Office Action Summary	Application No. 10/657,933	Applicant(s) HUANG, SUNNY E.L.	
	Examiner Travis M Reis	Art Unit 2859

DETAILED ACTION

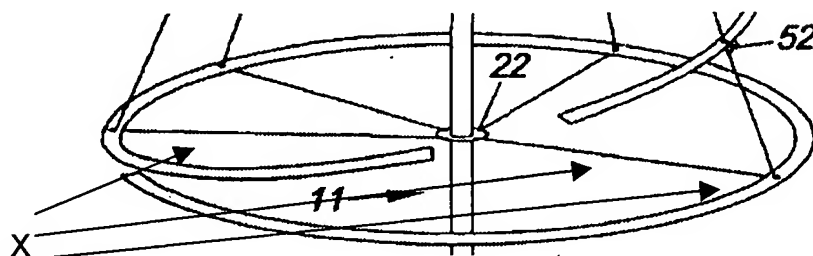
configuration formed of a band of resilient polymer material (Abstract); a base member (22) having a span (X, see below)

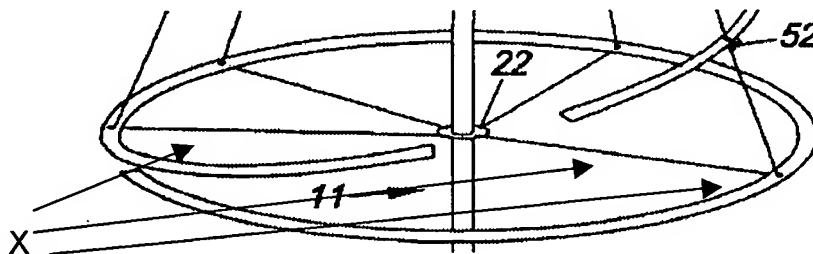
With reference to claims 11 & 12, Phillips discloses a resiliently expandable structure (10) in the shape of a cone comprising a structure (13), having an inherent spiral configuration formed of a band of resilient polymer material (Abstract); a base member (22) having a span (X, see below)
